plandescil
consulting engineers

SJR/EAP/25115

24 July 2019

Structural Appraisal of Bulging of Flint Wall to Rear (west) Elevation of Historic Portion of the Town Hall.
Site Visit: 18th July 2019
Weather: Mild and Overcast

SCHEMATIC ELEVATION
ON EXTERNAL PORTION
OF WALL.. (≈ 1:50)

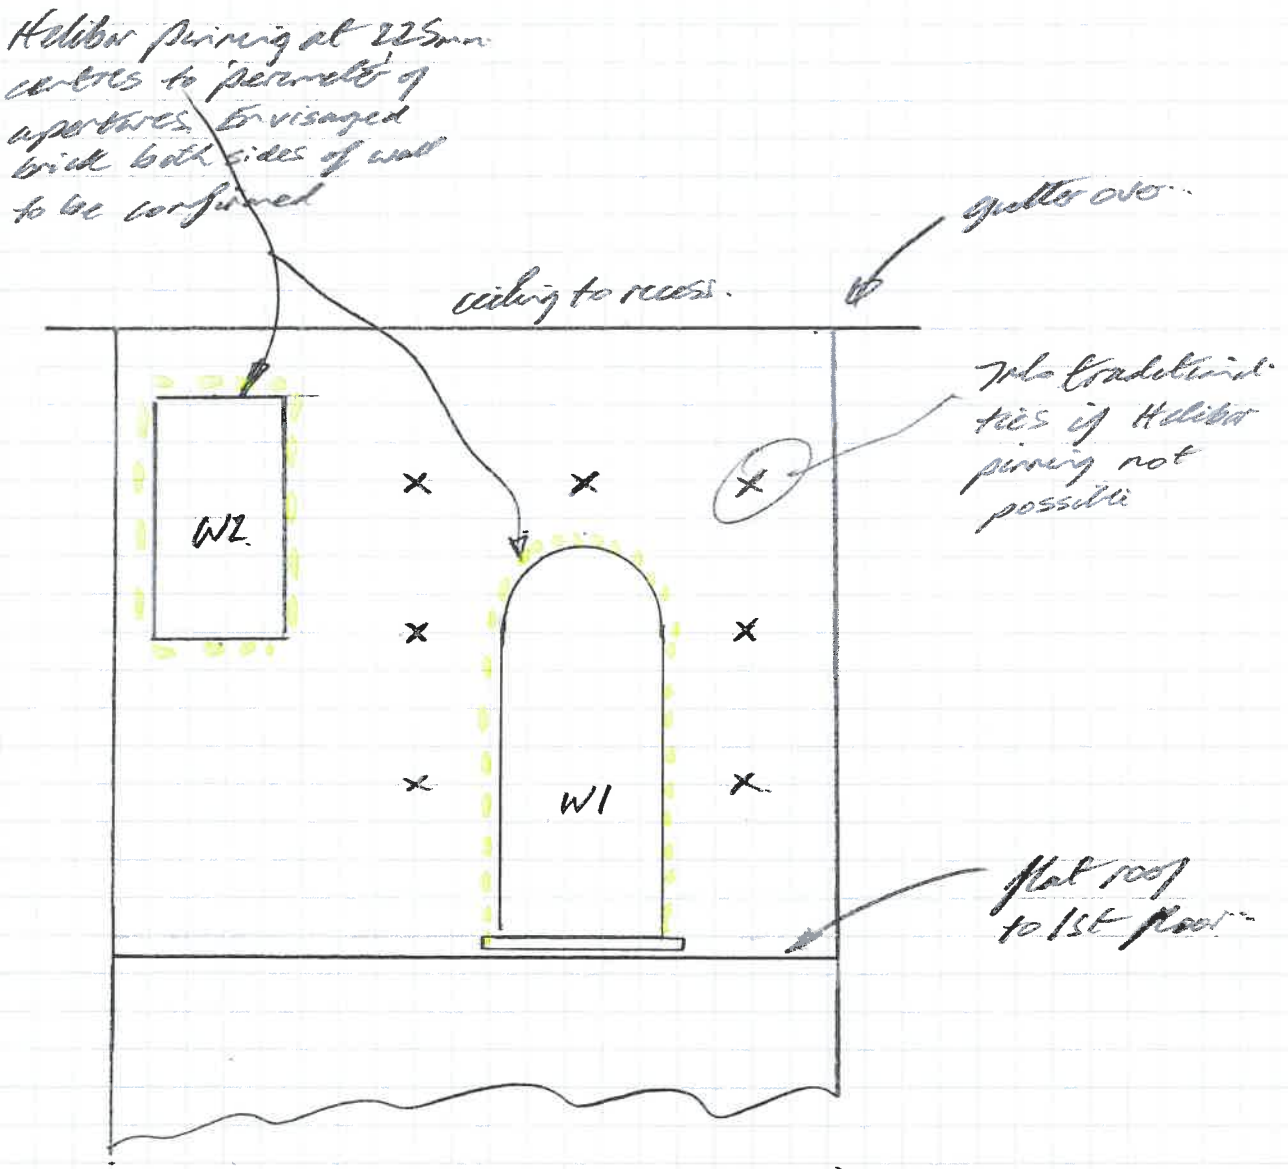
The scaffolding unfortunately prevented a clear photograph of the whole outside of the subject wall. However SK1 shows a schematic elevation on the externally exposed portion of the subject wall.

The left hand side encompassing the window W2 and below is in facing brick but elsewhere, apart from the brick W1 arch and ashlars, is in knapped flint.

The subject wall was gently bulged outwards on the outside face. No such corresponding movement was discerned on the inside face of the wall.

This indicates the wall is likely to be delaminating with the outside knapped flint gradually moving outwards. At this stage we do not know the nature of the inside face of the wall. A typical *rubble* wall would generally have an inner and outer leaf constructed in a lime mortar (often flint/flint or flint outer/ chalk inner or numerous less likely other variations). The middle of the wall was then *crudely* infilled with reject stone for the outer leaves and varying amounts of mortar. These outer leaves were not tied together and with the passage of time the outer leaf typically moves outwards from the effects of repeated heating/cooling, wetting/drying. The inner skin is bound together by the internal finishes and is not affected by the weathering effects and hence, as here, is often not prone to movement.

(W1) Top of arch

- 12mm new gap beyond historic repointing.
- Historic repointing 40mm say allow initial 10mm gap gives previous 30mm movement.
- Approximate total outward movement 12+30=42mm.

(W2) Top of arch

- 7mm new gap beyond historic packing.
- Loose historic packing circa 20mm (less 10mm initially).
- Total movement circa 17mm

2) Window (W2)

If you are uncomfortable with the loss of alignment then the flat arch needs to be removed and rebuilt. If not insitu stabilisation could be adopted.

We would envisage Helibar *pinning* the entire perimeter of window back to the *inner leaf/*backing wall at 225mm centres if this is technically possible with the wall materials found.

3) Window (W1) semi-circular 218mm long brick arch

- If possible insert at most appropriate levels (i.e. easiest to achieve) two lines of 2No. 6mm Helibars (in nominal bed horizontal coursed beds of knapped flint) in accordance with LR03/LR04 guidance. All to *help* the arch and remediate minor cracking to above the arch head.
  Vertical pinning cannot be undertaken into the flint.

- Helibar pin together 5No. broken bricks within arch.

- Helibar pinning to the perimeter (3No. sides) of the window back to the inner leaf/backing wall at 225mm centres.

4) Wall Panel

If technically possible install Helifix remedial ties between front leaf and inner leaf/back wall at staggered broadly 450mm centres in both directions.

7No. traditional ties in total as depicted on SK1 and in section on SK2.

TYPICAL SECTION ON TRADITIONAL TIE ROD PROVISION (IF NEEDED)..

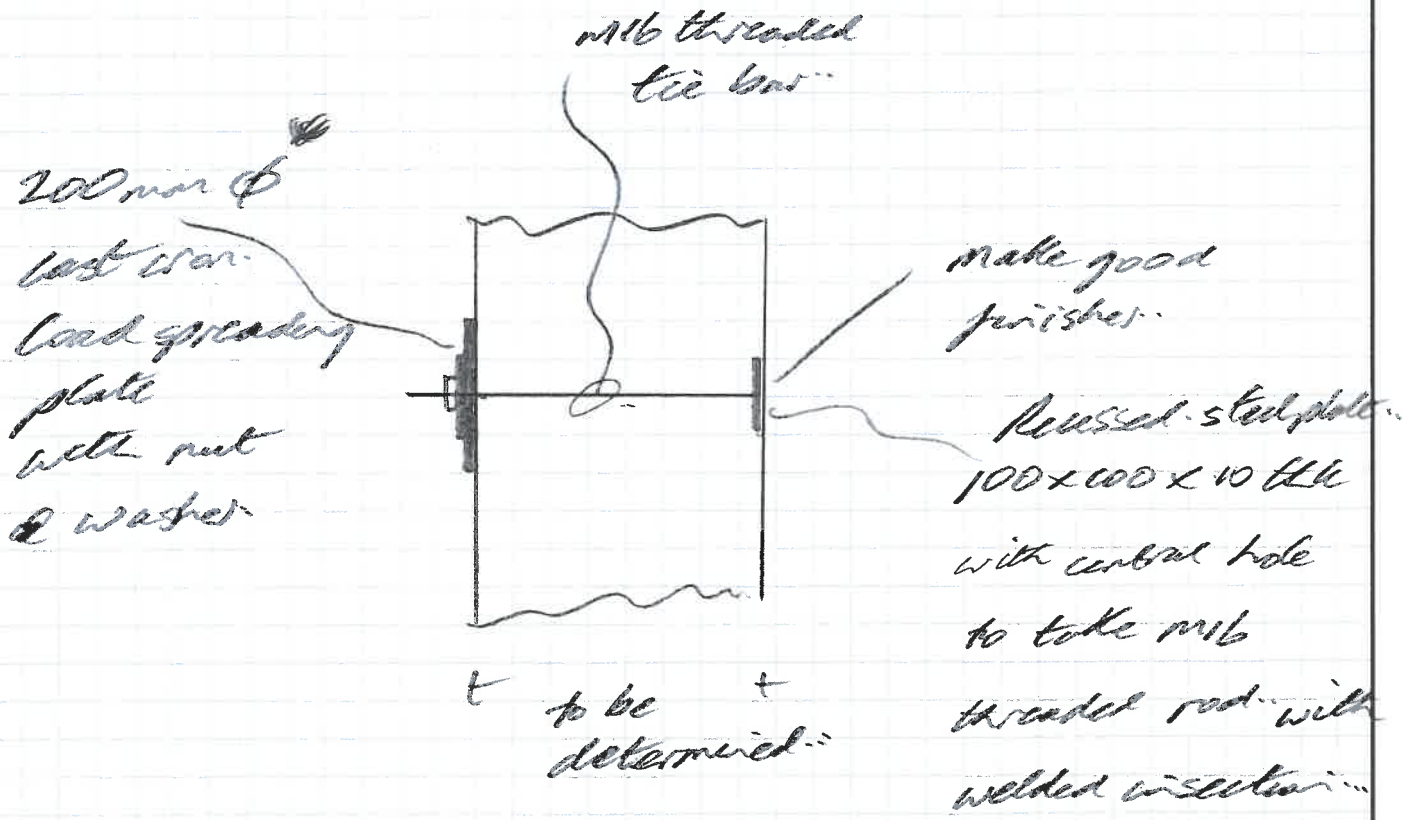
If this proves to be unfeasible revert to traditional through ties with steel pattress plate. Internal plates to be cut into the finished/wall in order to be disguised. Externally 200mm Ø cast iron load spreader plate.

* Cast iron plate available from East Coast Casting Carbrooke.. 01953 881741..
